SUBJECT: Advises that Figures 1 & 2 were omitted from util 810421 response to NRC 810209 request for addl info on seismic design of standby shutdown facility. Complete response encl.

Re: Oconee Nuclear Station
Docket Nos. 50-269, -270, -287.

REQUEST FOR ADDITIONAL INFORMATION
OCONEE NUCLEAR STATION
DUKE POWER COMPANY
DOCKET NOS. 50-269, 50-270, 50-287

Fig. 1

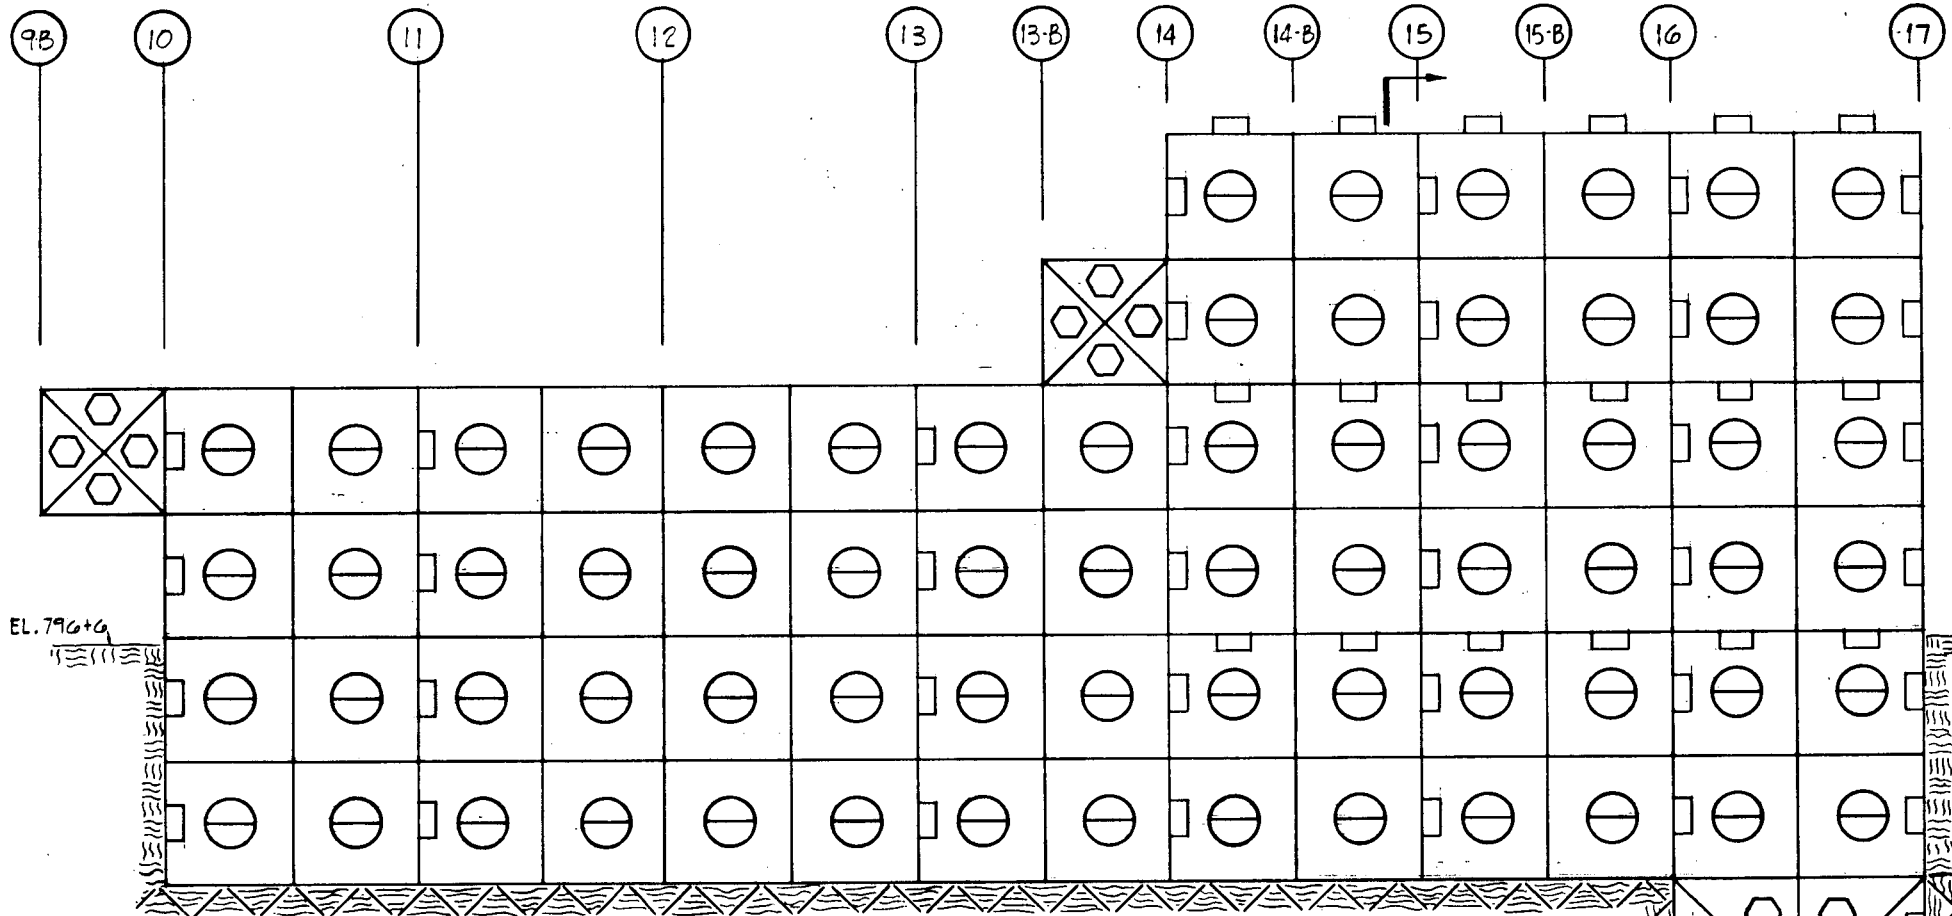
Question 1 - Provide the mathematical model that is used in your earthquake response analysis of SSF. The model should show mass points, their coordinates, damping and spring arrangements and their corresponding numerical values as well as appropriate configurations of soil and bedrock foundation. In particular, provide a reasonable discussion as to how the embedded portion of the building below the ground level is modeled and how soil-structure interaction is considered. If no such soil-structure interaction is considered, please justify the proposed design by discussing why the model without soil-structure interaction represents a conservative dynamic model.

Response - The mathematical model used in the analysis of the Standby Shutdown Facility (SSF) is illustrated in Figures 1 and 2 attached. The model accurately represents the geometry of the structure, and is analyzed both dynamically and statically as a space frame. A damping ratio of .05 (5%) was used in the seismic analysis. One-half of the inertia (mass) of each beam is lumped at each model node. One-quarter of the mass of quadrilateral elements and one-third of the mass of triangular elements are applied to each mass point (model node).

The Standby Shutdown Facility is a reinforced concrete structure erected on continuous rock. The rock properties are similar to those used for the soil-structure interaction analysis for the Catawba Nuclear Station (Reference: Catawba Nuclear Station PSAR, 3.7.1.6, Docket Nos. 50-413 and 50-414). Since the structures at the two stations are similar, the results of the interaction analysis for Catawba are also applicable here. It was concluded in the Catawba analysis that the effect of soil-structure interaction on the frequencies and mode shapes was small and can be neglected. Consequently, for the purpose of seismic analysis, the structure is considered with a fixed base.

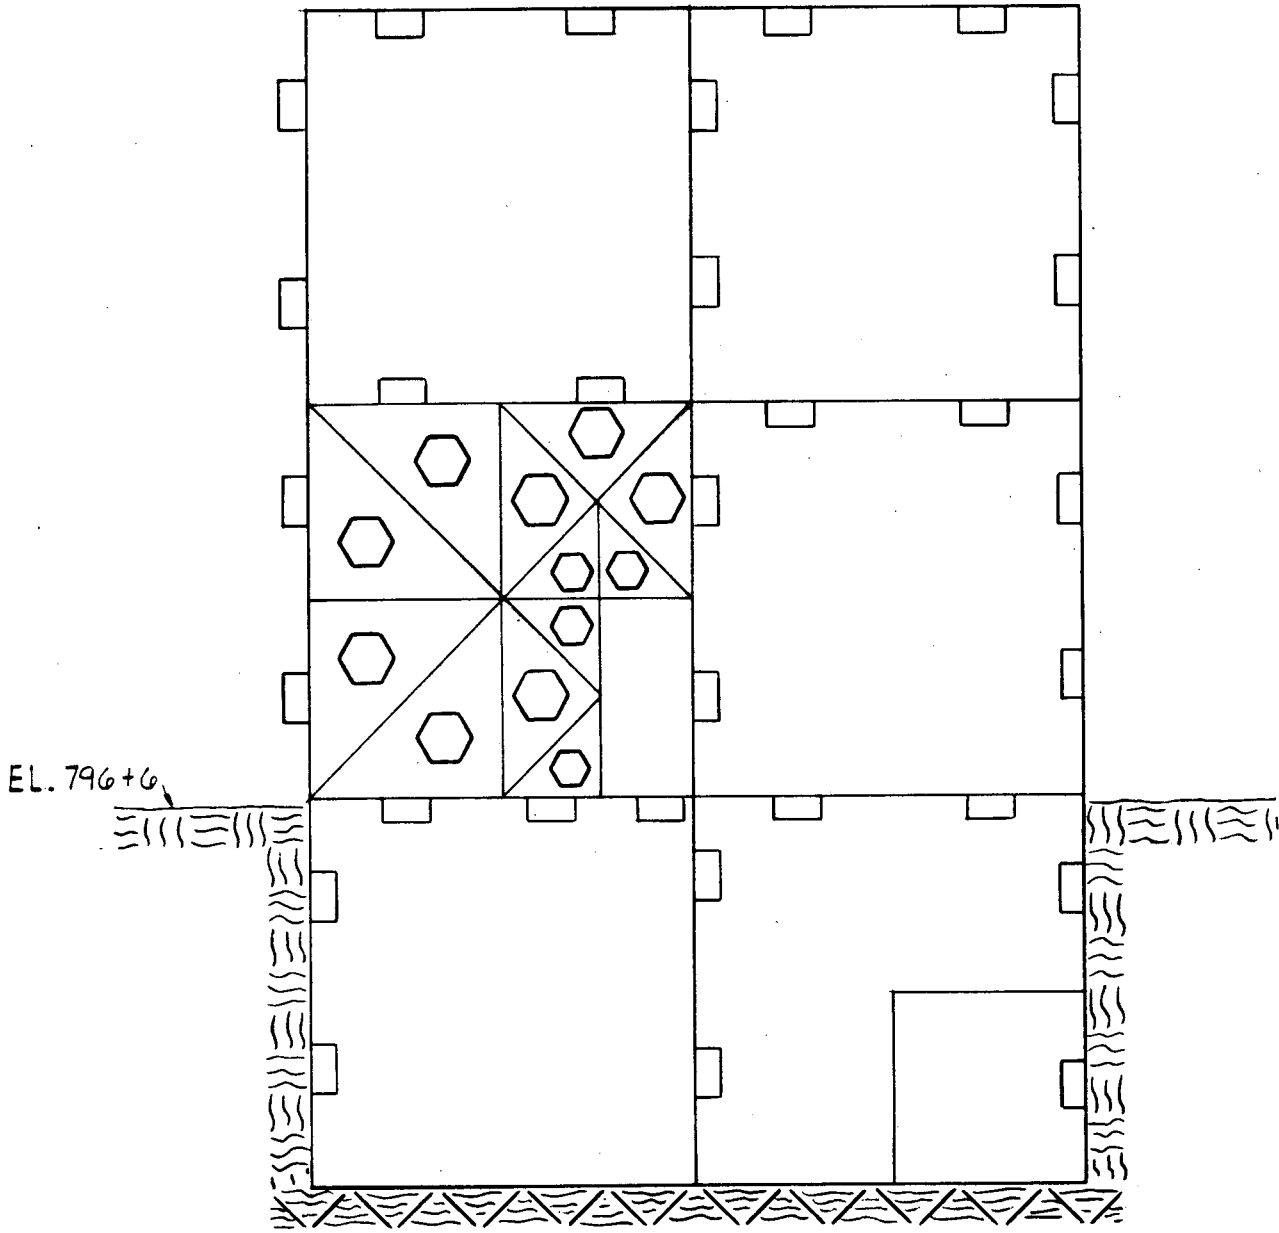
Question 2 - Discuss where the 0.10g bedrock acceleration is applied. Indicate the location of application in the model requested in Question 1 above.

Response - The 0.1g bedrock acceleration is applied to the model nodes located at the base of the structure.
